Subject: Oconee Nuclear Station  
Docket Numbers 50-269, 270, and 287  
Supplemental Response to Request for Additional  
Information Pertaining to Defense in Depth and  
Diversity Assessment Associated with the Digital  
Upgrade of Oconee's Reactor Protective System and  
Engineered Safeguards Protective System

### NRC Request for Additional Information (RAI) Associated with the Digital Upgrade of Oconee's Reactor Protective System and Engineered Safeguards Protective System

#### RAI 7

Figure A-1

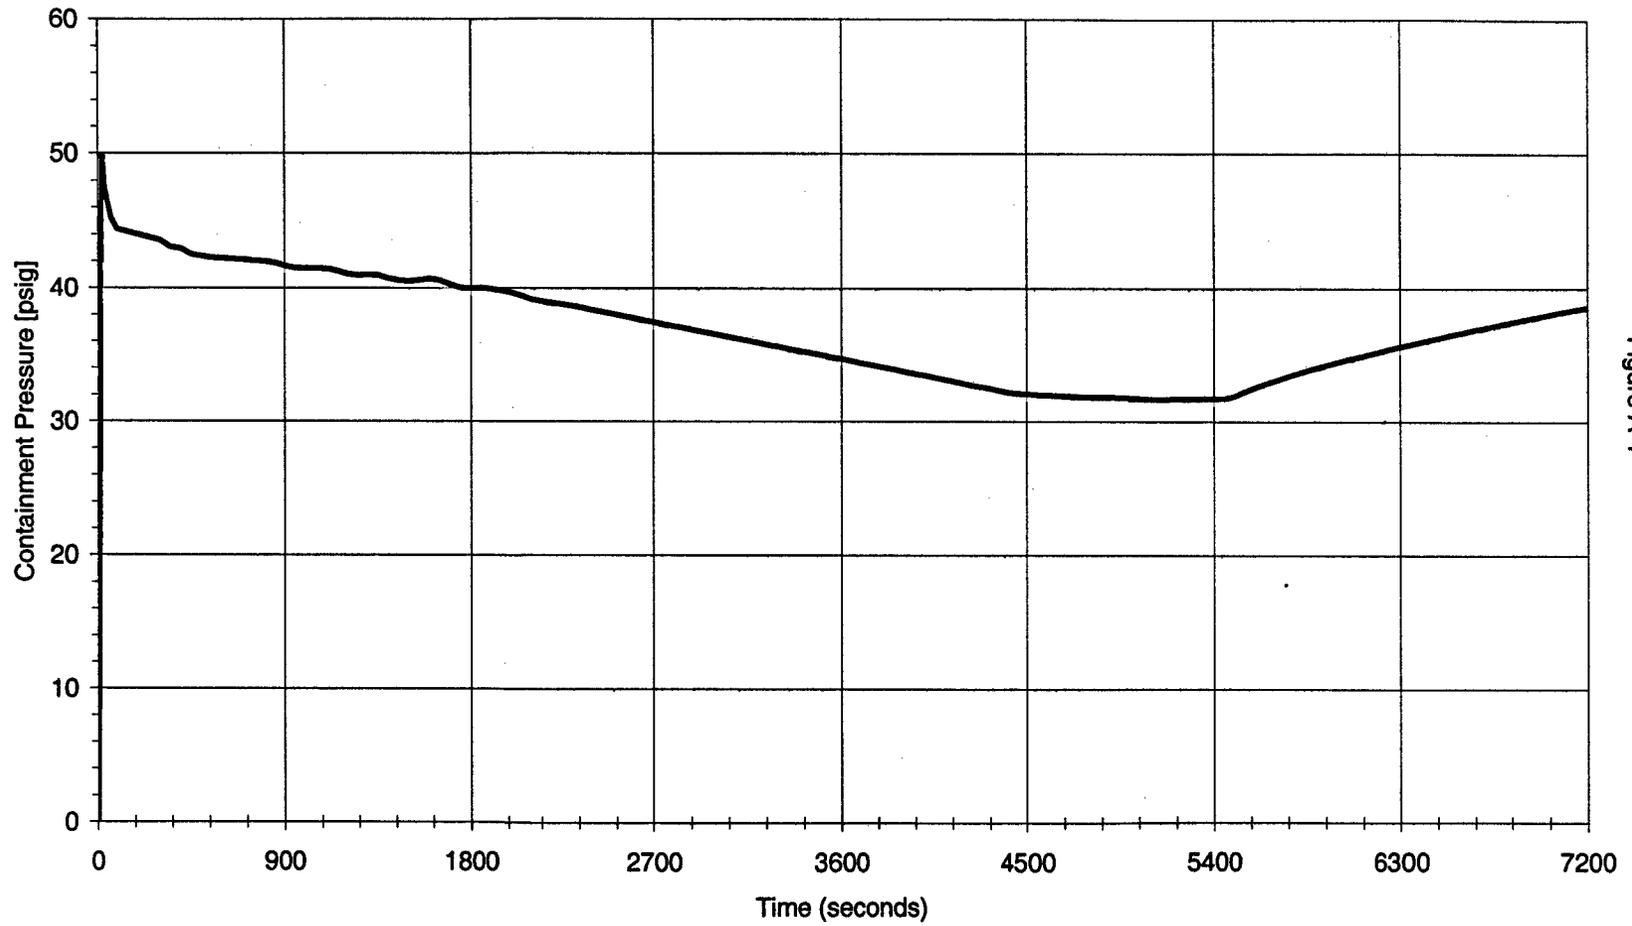
How much time *is available for operators to take the actions such that accident acceptance criteria are met (reactor coolant system overpressure, radiological, reactor building pressure, coolable geometry)?*

To demonstrate this effect, a design basis large break LOCA case was reanalyzed without actuation of either the RBCS or RBS. The containment pressure response is presented in Figure A-1 for the initial 2 hours of the case. As illustrated in Figure A-1, the initial pressure peak is not exceeded for the initial hour of the event, as pressure continues to decrease. RB pressure does begin to increase, but only after 1.5 hours has elapsed. This case assumes prompt ECCS injection to the RCS. In order to provide a continuous mass and energy release, it is necessary to assume that either prompt operator action is taken to initiate HPI and LPI, or that the ES actuation for these functions is not affected by an Reactor Protective System (RPS)/Engineered Safeguards Protective System (ESPS) software common mode failure. Thus it may be concluded that variations in the operator action time to initiate HPI and LPI are not critical for this acceptance criterion.
